ADDENDUM NO. 3

February 6, 2023

**SOLON ROBINSON ELEMENTARY SCHOOL ADDITIONS,
RENOVATIONS, AND RELATED WORK
Crown Point, IN 46307**

A-121

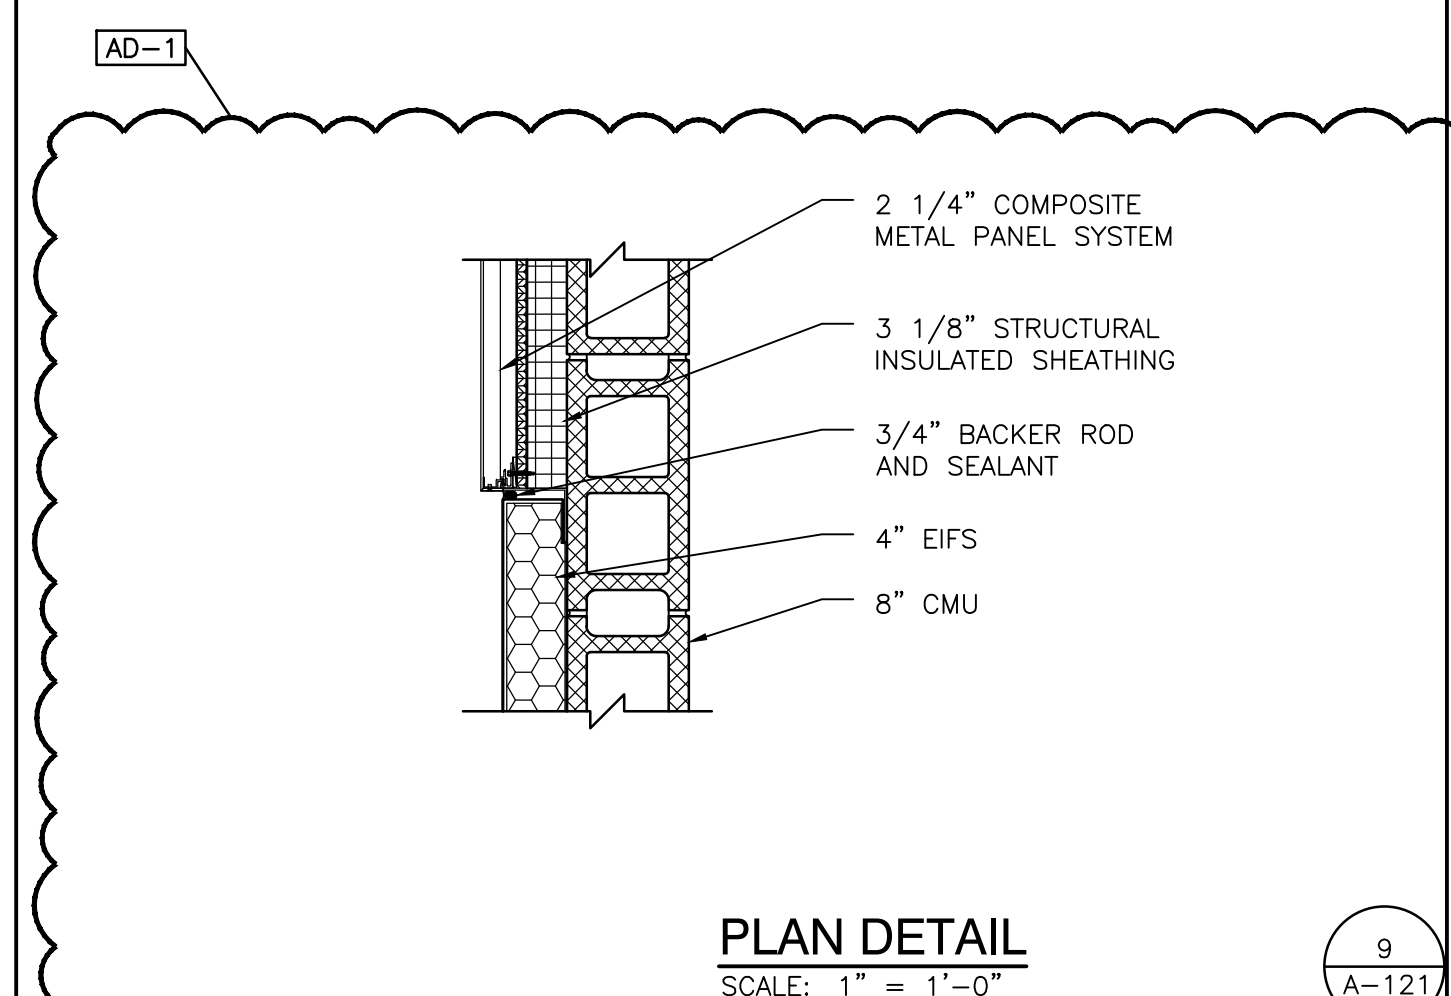
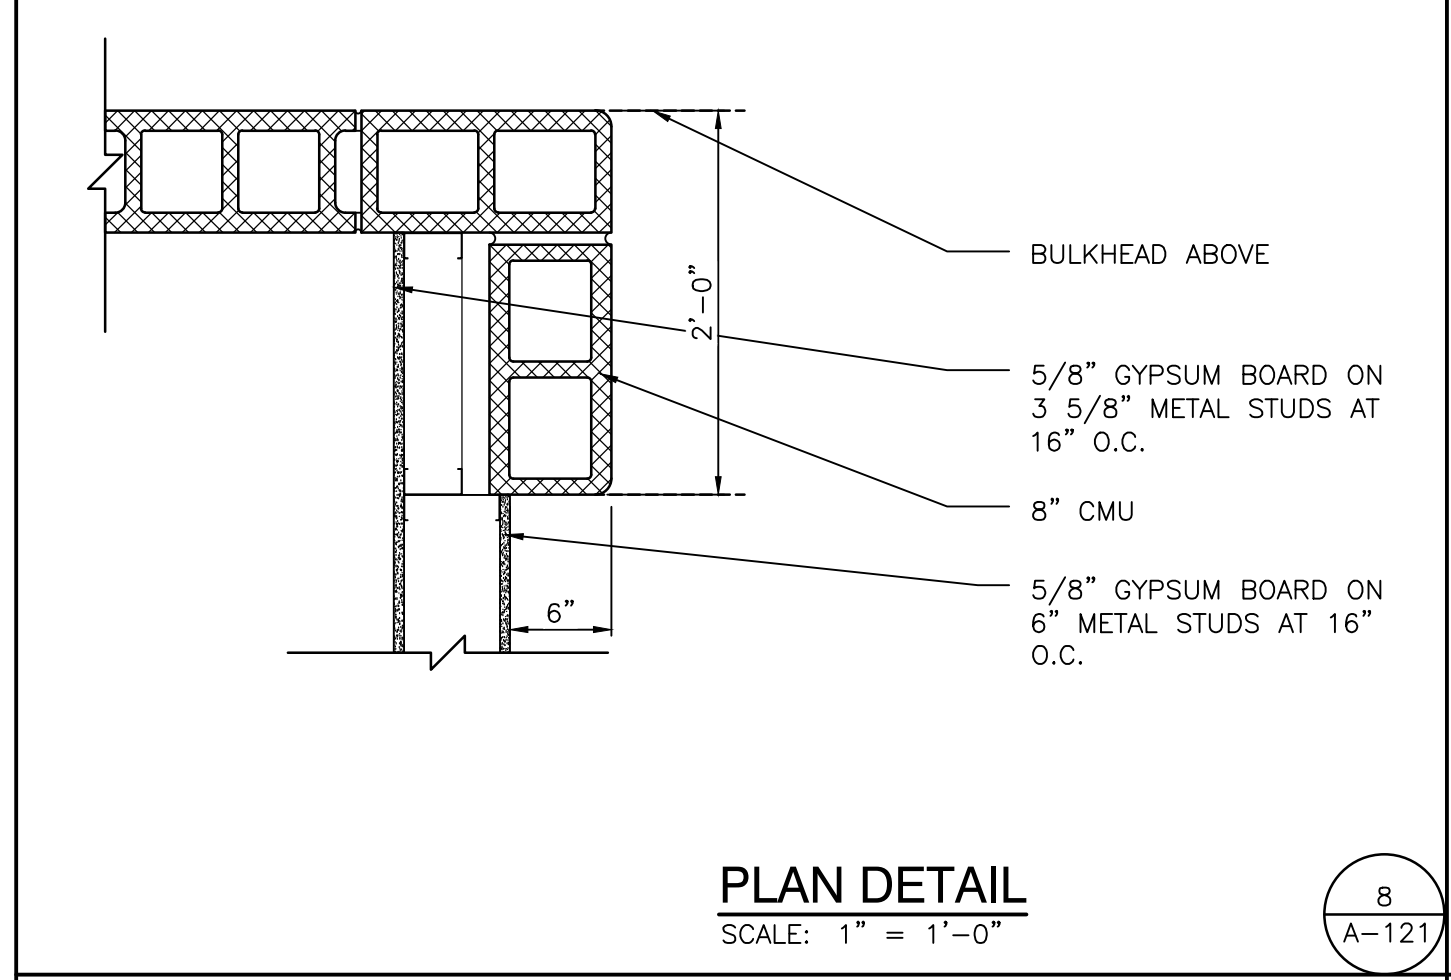
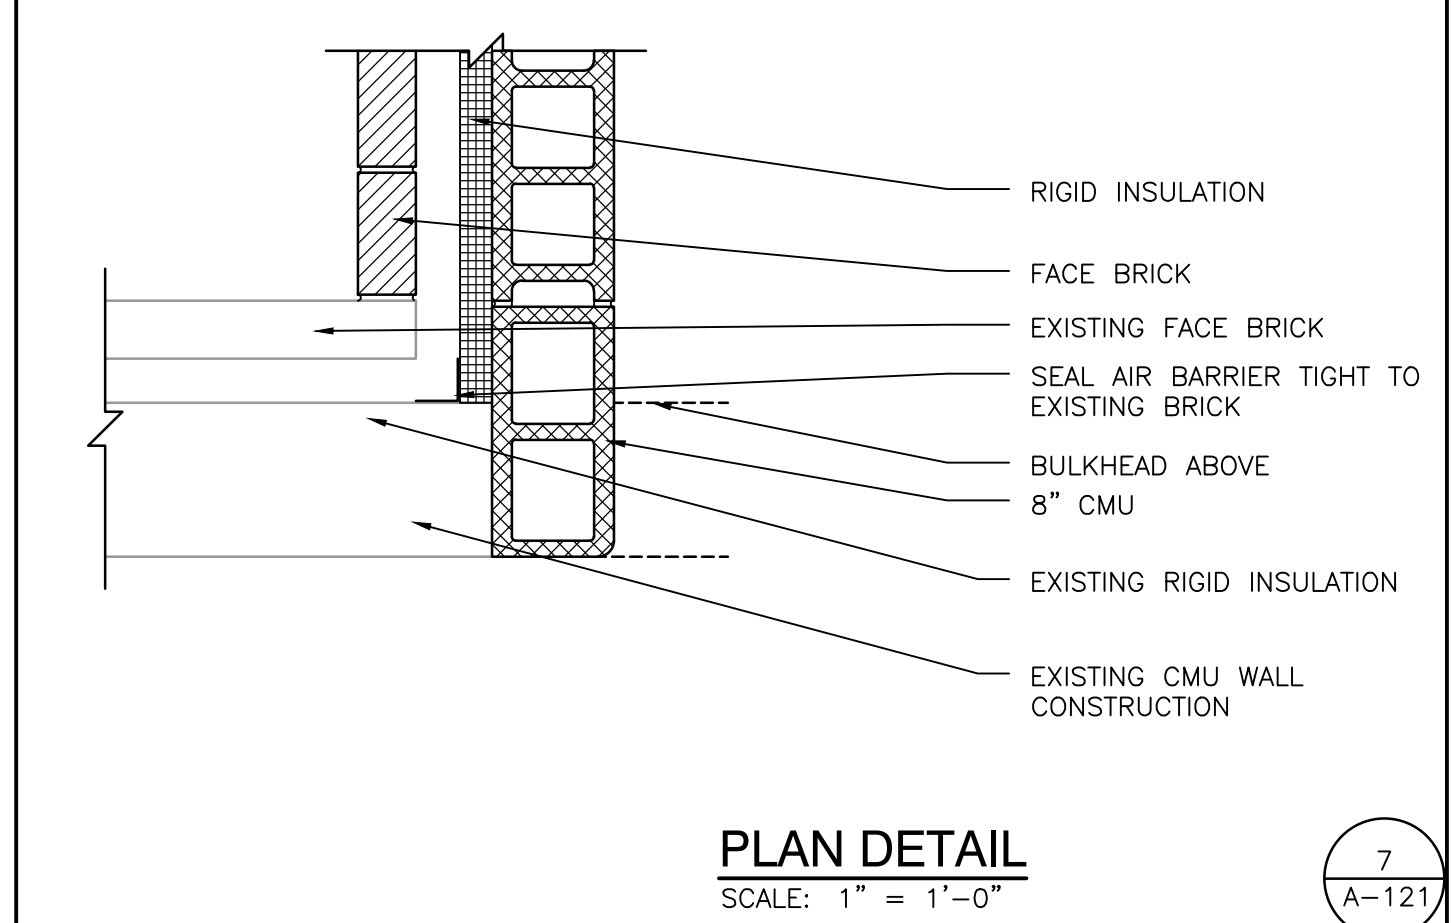
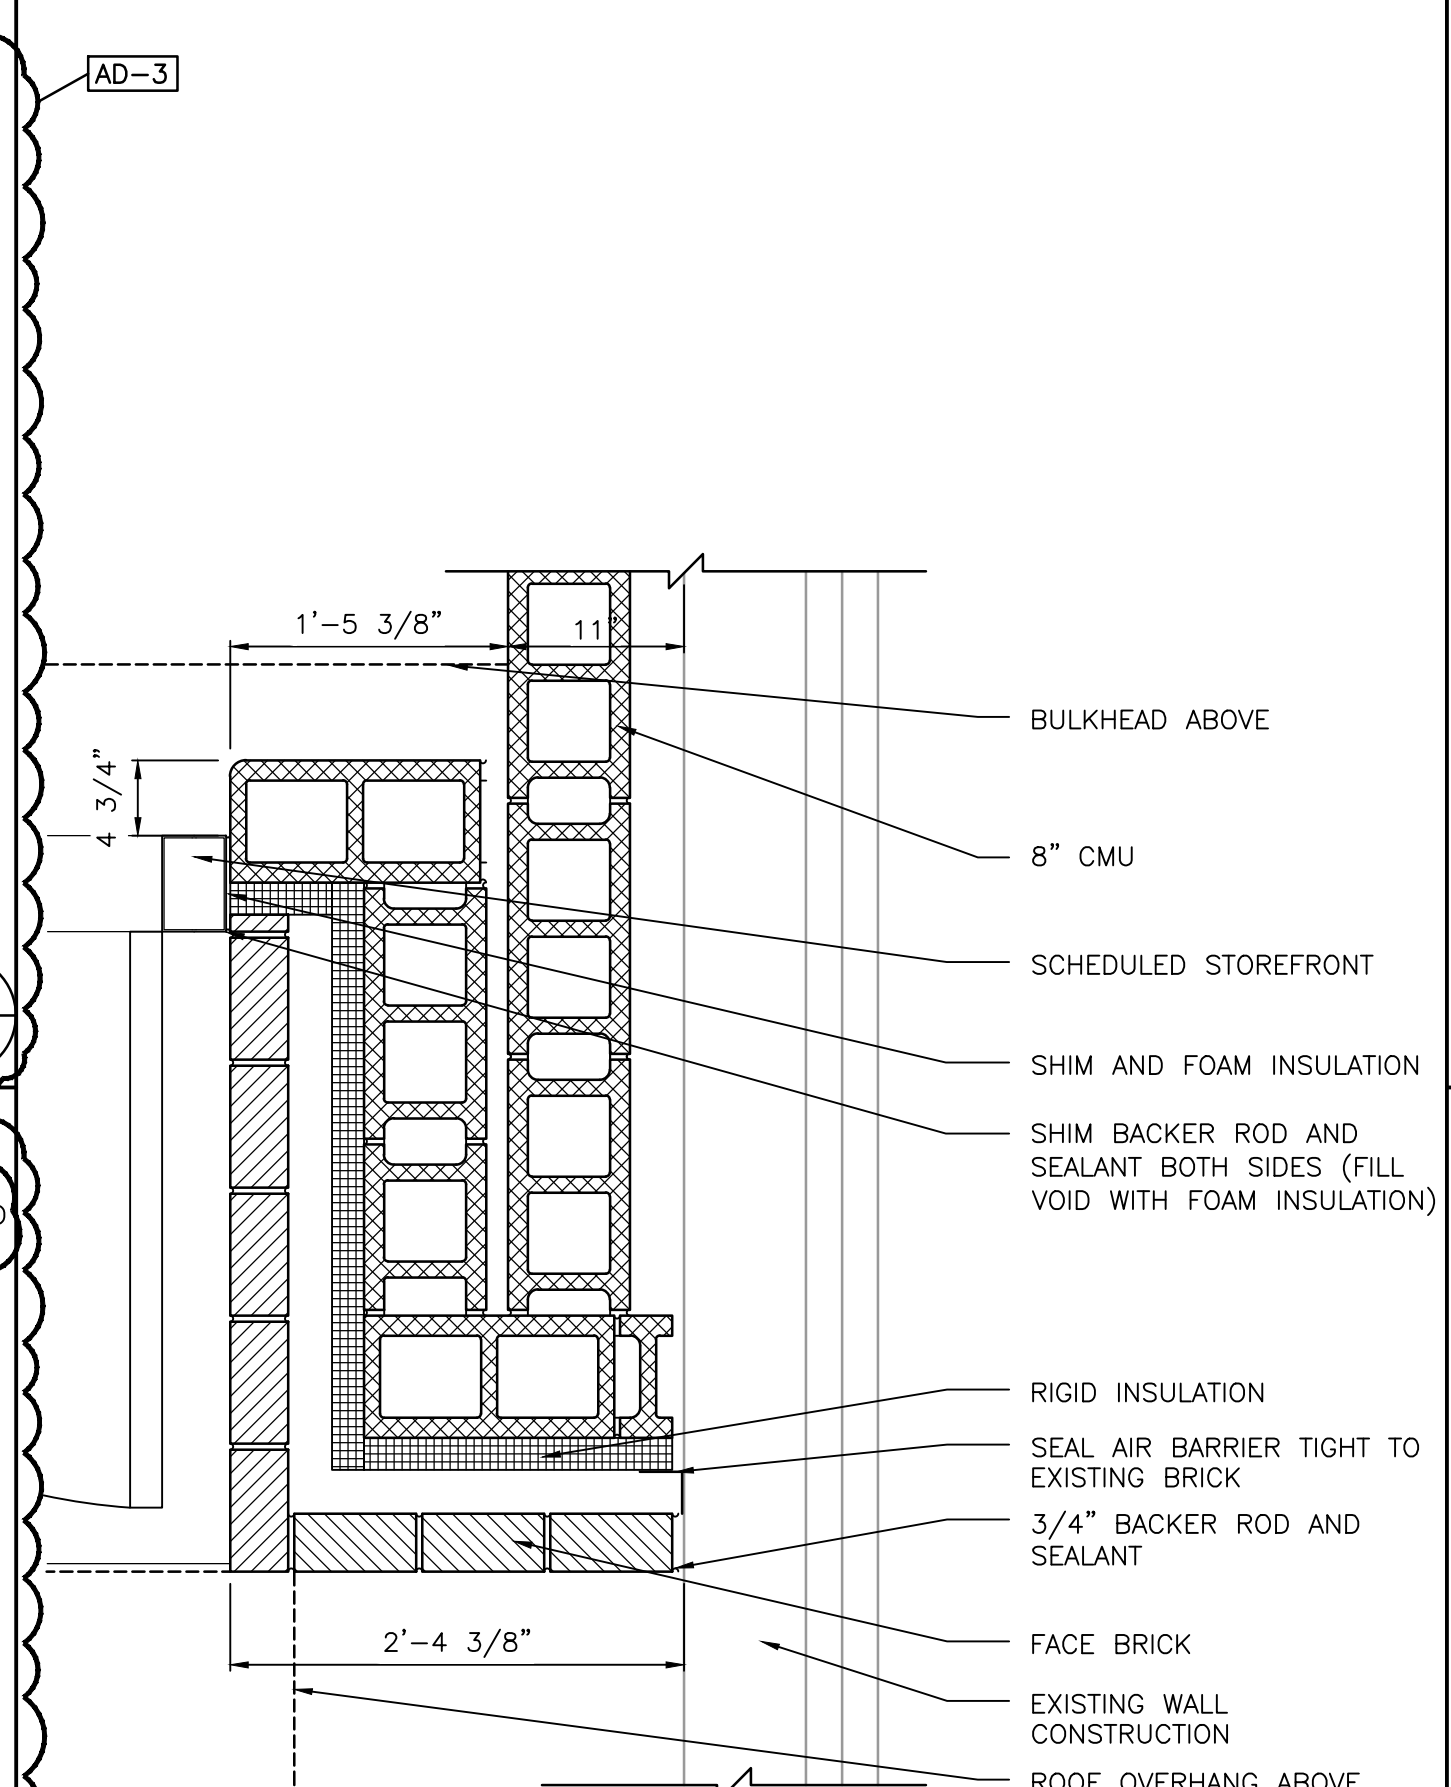
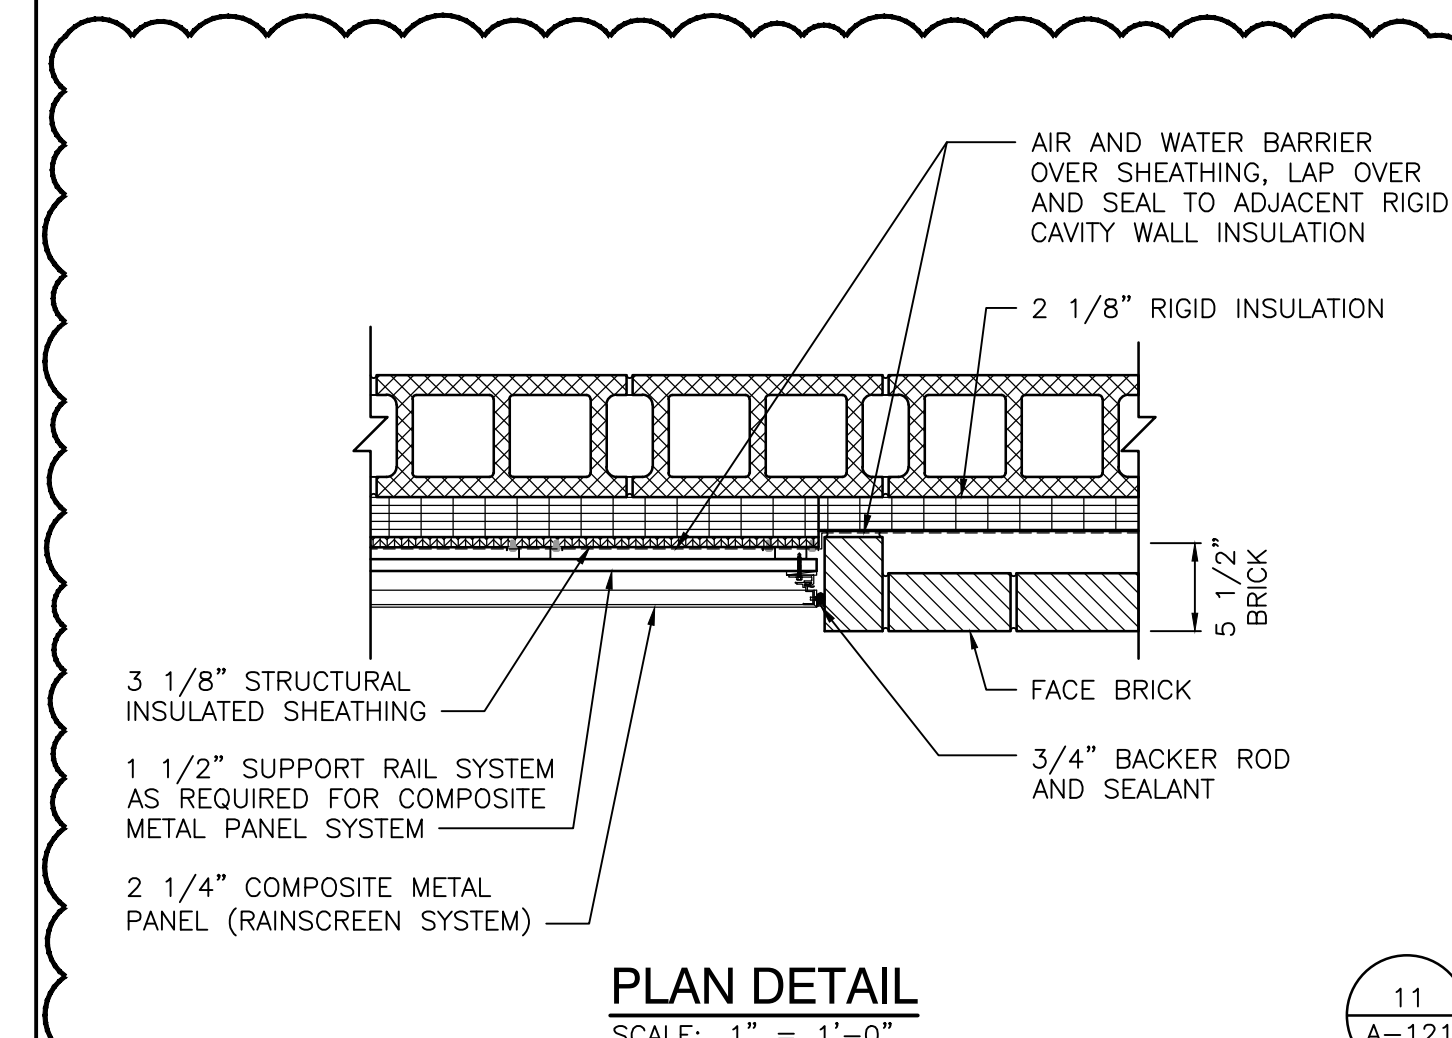
- A. Add new Plan Detail 11.
